AGENDA OF THE PLANNING BOARD

September 1, 2022

Re: 71 S. MESIER AVENUE
Response to Planning Board Comments

Re: 2 Delavergne Avenue
Amended Site Plan Application
Tax Grid No.: 134601-6158-10-268607

STORMWATER MANAGEMENT PLAN
 SCALE: 1" = 5'

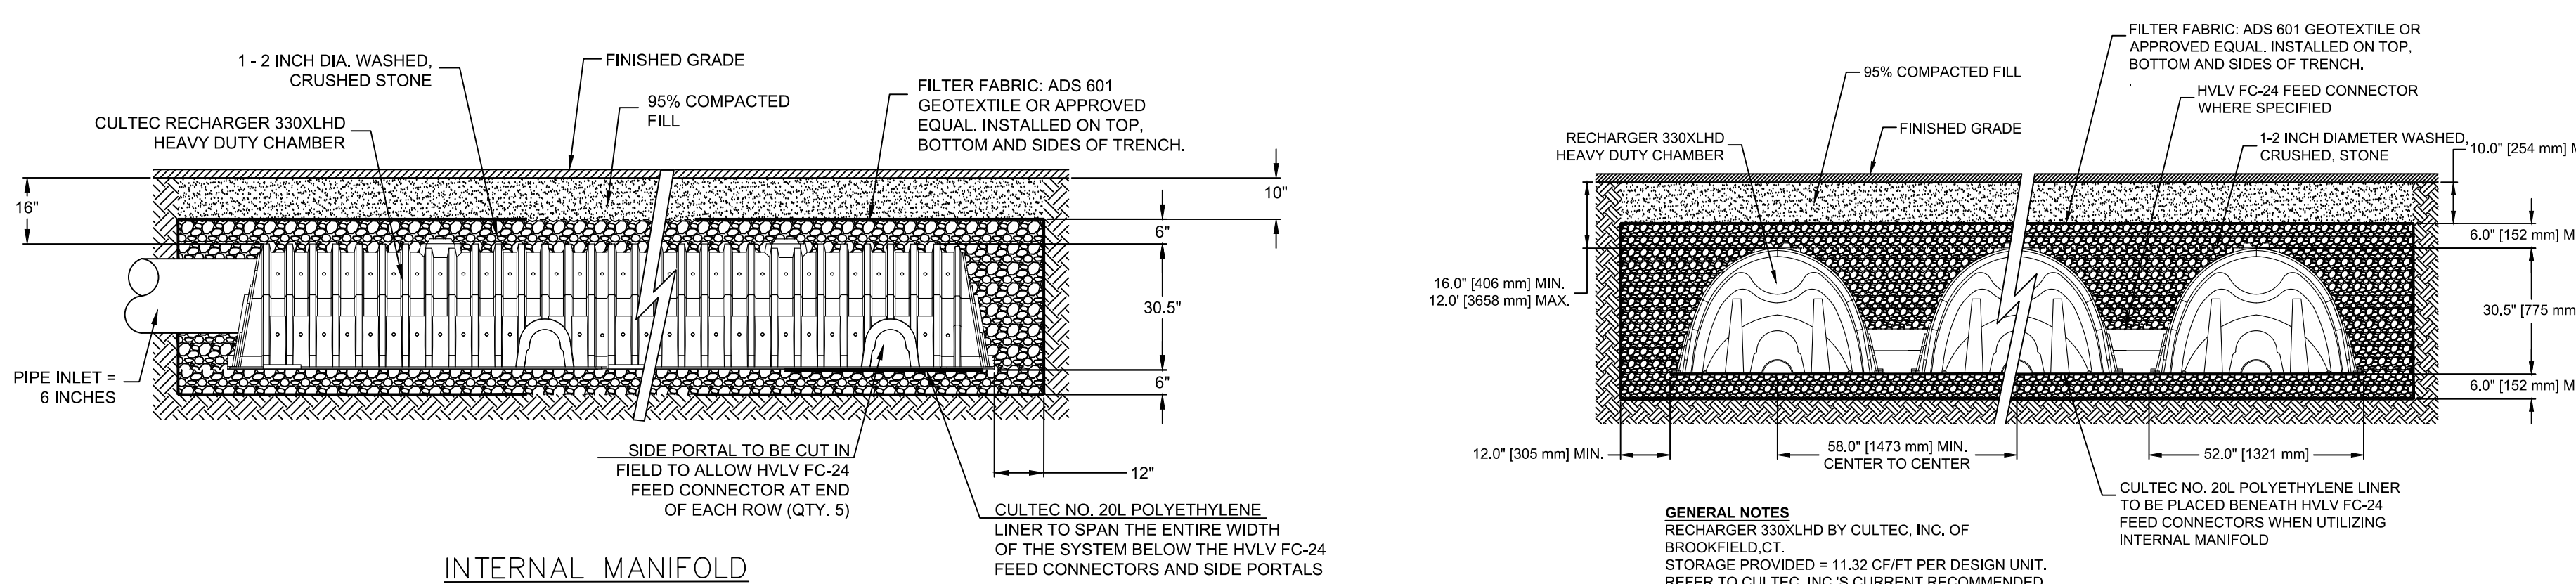
5. *Comment: Stormwater management of all new imperious surfaces should be provided. It is noted in the SEAF that stormwater will either be discharged to the yard or the storm drains. Please clarify. If discharging to Route 9D, a NYSDOT work permit will be required.*

Response: Proposed stormwater management facilities are now indicated on the Sheet C200, which demonstrate 100% mitigation of newly generated runoff resulting from the 100-yr storm.

Drawing Title
UTILITY AND GRADING PLAN

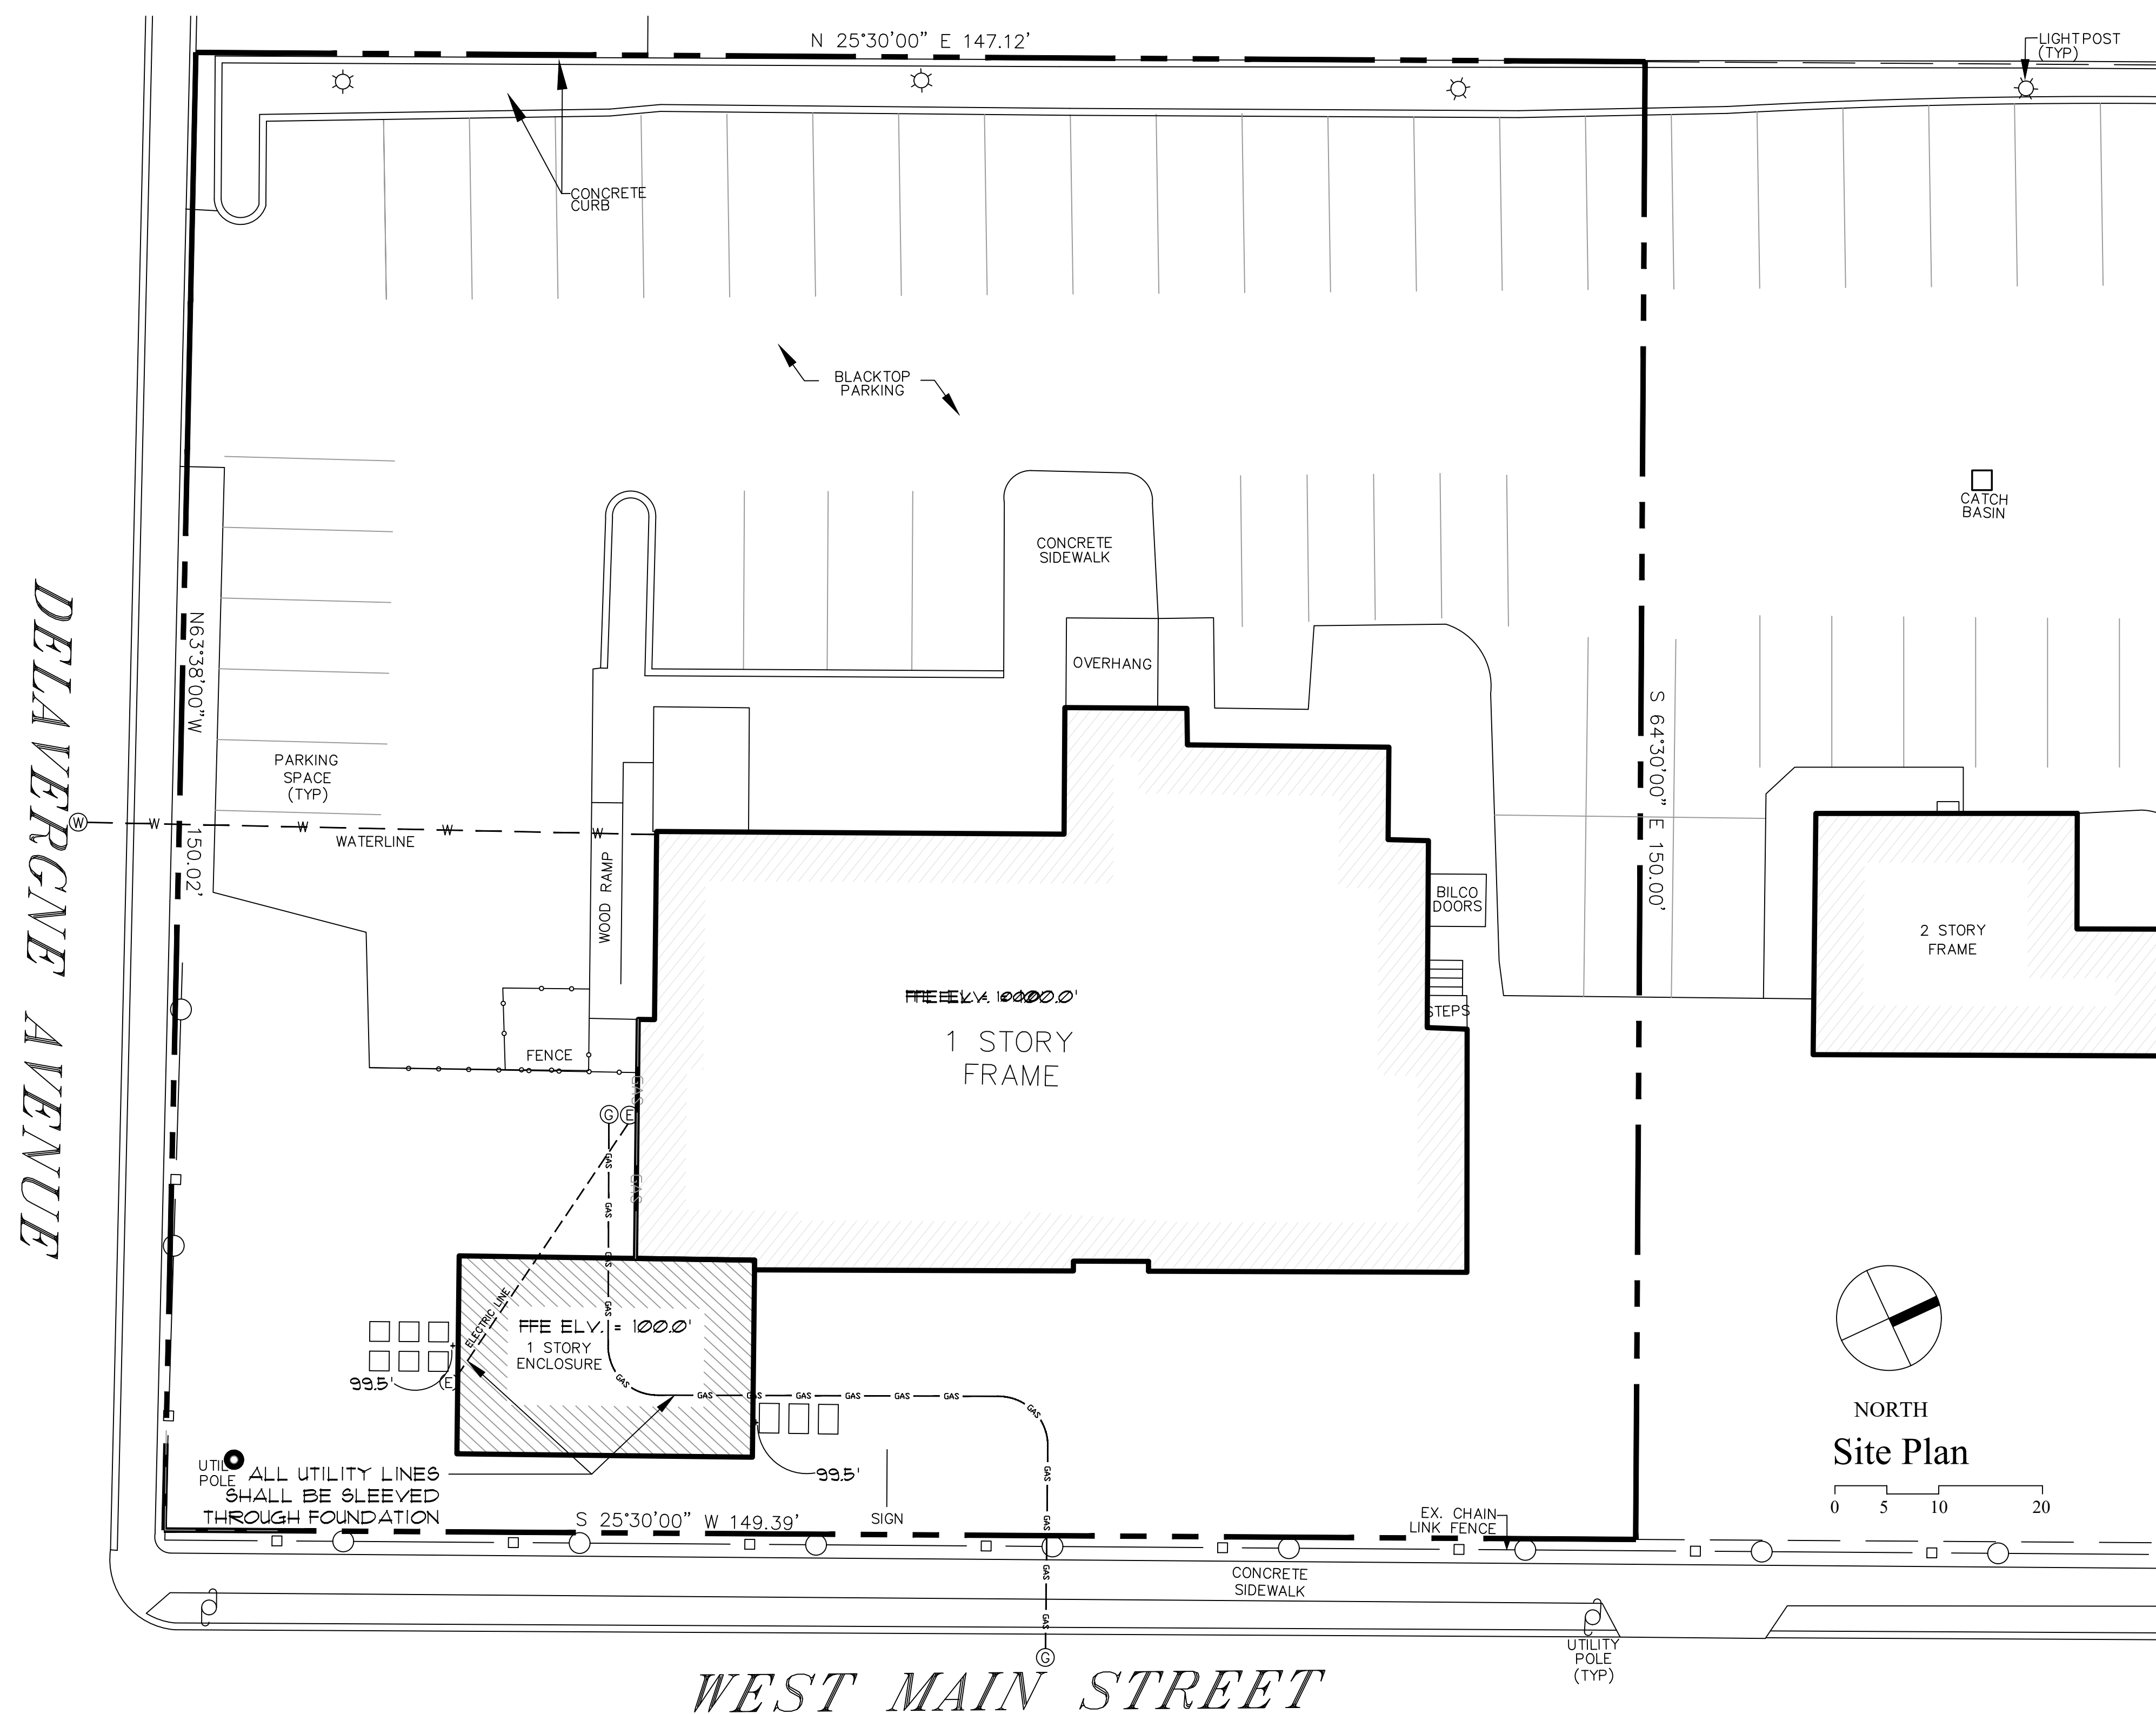
2. Comment: *Show all existing and proposed utilities; water, sewer, electric, gas, and telephone lines. If new infrastructure is required, provide details, profiles, and types of materials proposed.*

4. *Comment: Plans should include topography or spot elevations for the site. Will the finish floor of the sunroom be the same height as the building finish floor?*

Response: Existing utilities are now identified on Sheet L300. At this time, only new drainage utilities are proposed, which are indicated on Sheet C200.

Response: Several spot elevations are now indicated on Sheet L300. The finished floor of the proposed sunroom will be the same as the existing building finished floor.
